SUBJECT: Forwards response to request for addl info on SER Open
Items 31,47,365 & 139/369.

SHEARON HARRIS NUCLEAR POWER PLANT
UNIT NOS. 1 AND 2
DOCKET NOS. 50-400 AND 50-401
RESPONSES TO REQUESTS FOR ADDITIONAL INFORMATION

ATTACHMENT

Number: F-0.2	Title: CORE COOLING	Rev. Issue/Date: HP/LP, REV. 1 1 Sept., 1983
-------------------------	-------------------------------	--

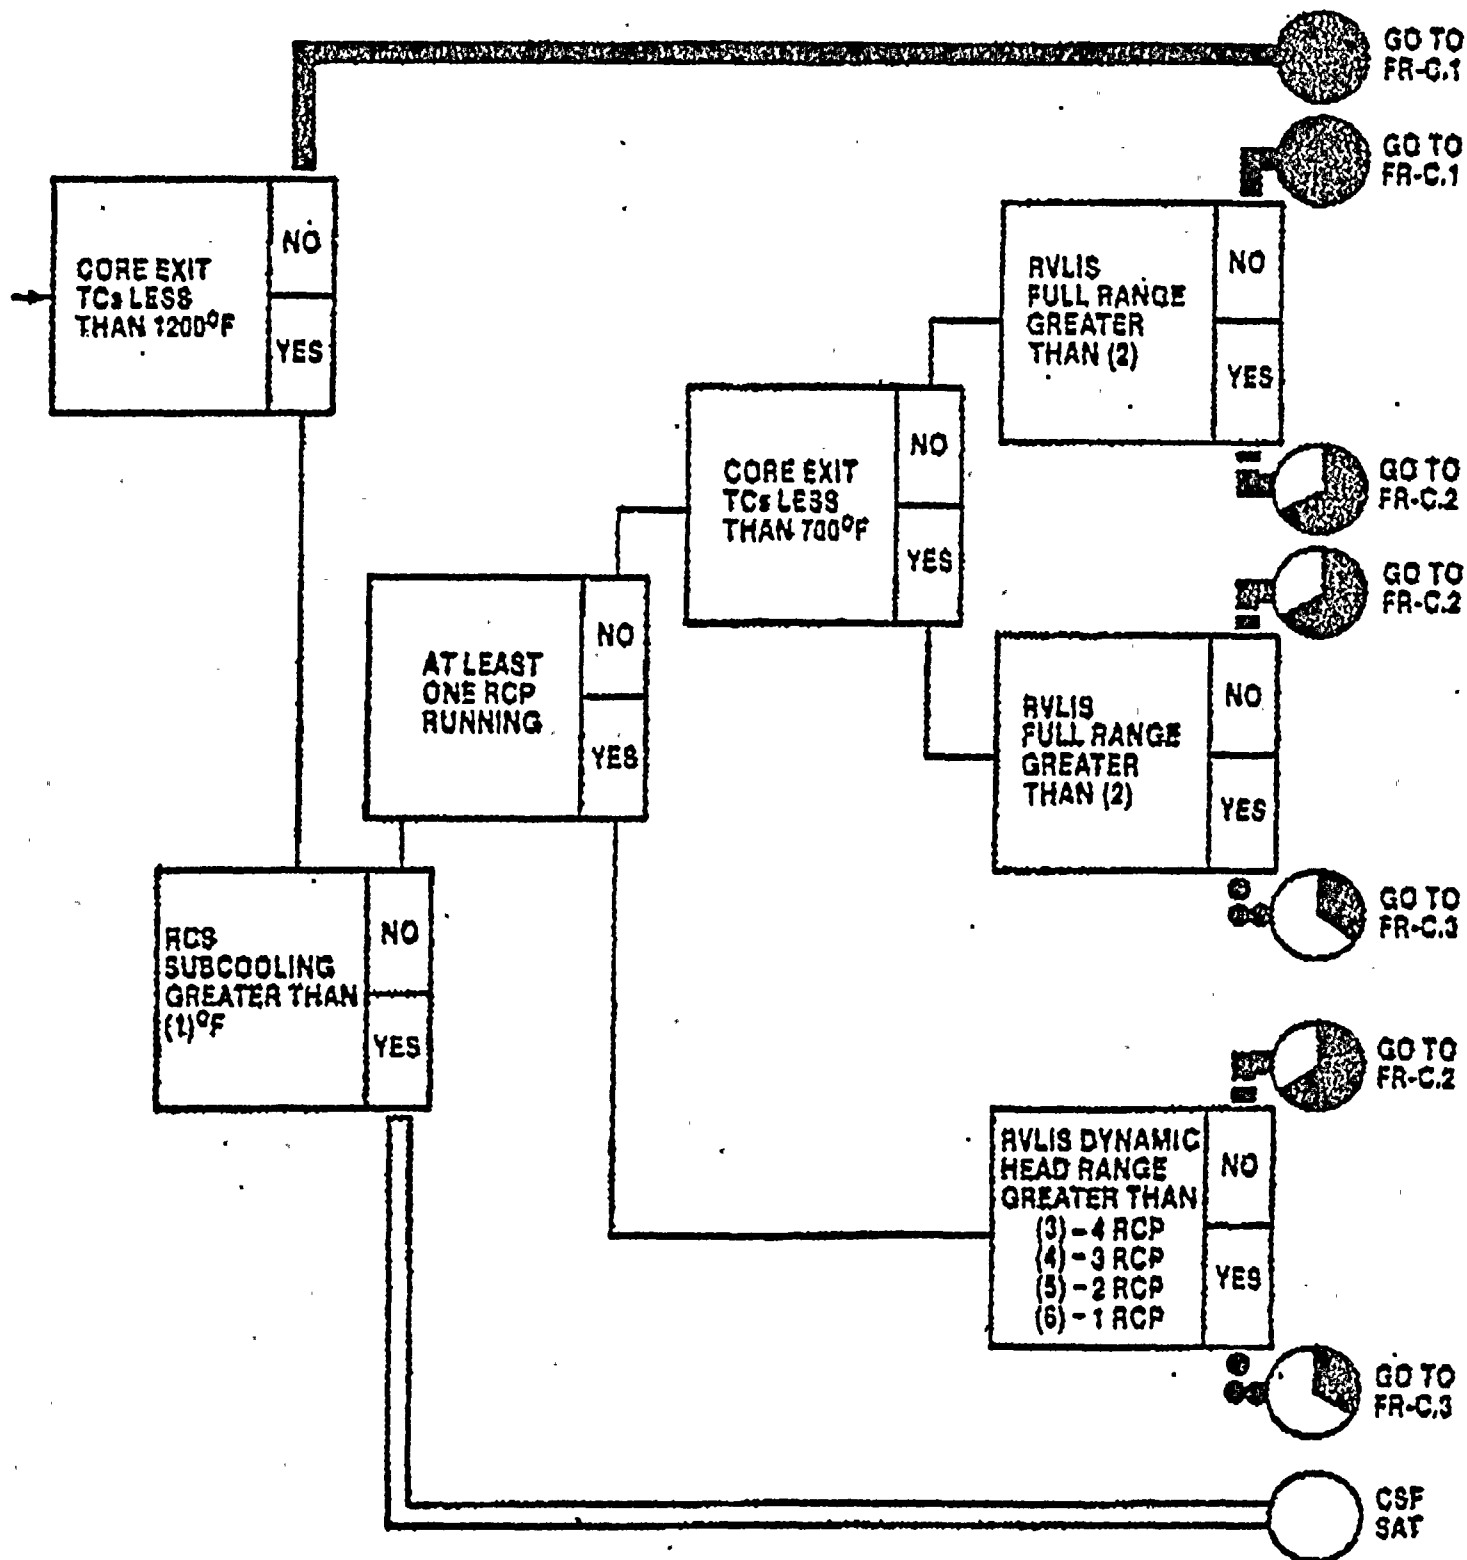
FRG C.1 This guideline will be used when indicated by the core cooling critical safety function status tree (refer to Attachment 1). The operator actions specified include:

FRG C.2 This guideline will be used when indicated by the core cooling critical safety function status tree (see Attachment 1).

FRG C.3 This guideline will be used when indicated by the core cooling critical safety function status tree (refer to Attachment 1).

- (a) Verify safety injection actuation and flowpath alignment.
- (b) Align and actuate systems required to support reactor coolant pump operation.
- (c) Monitor containment hydrogen concentration.
- (d) Operate pressurizer PORV, if necessary.
- (e) Operate steam system PORVs.
- (f) Actuate reactor coolant pumps.

The sequence, priority, and action levels for the listed actions are based on ICC instrumentation and other post-accident monitoring capability.
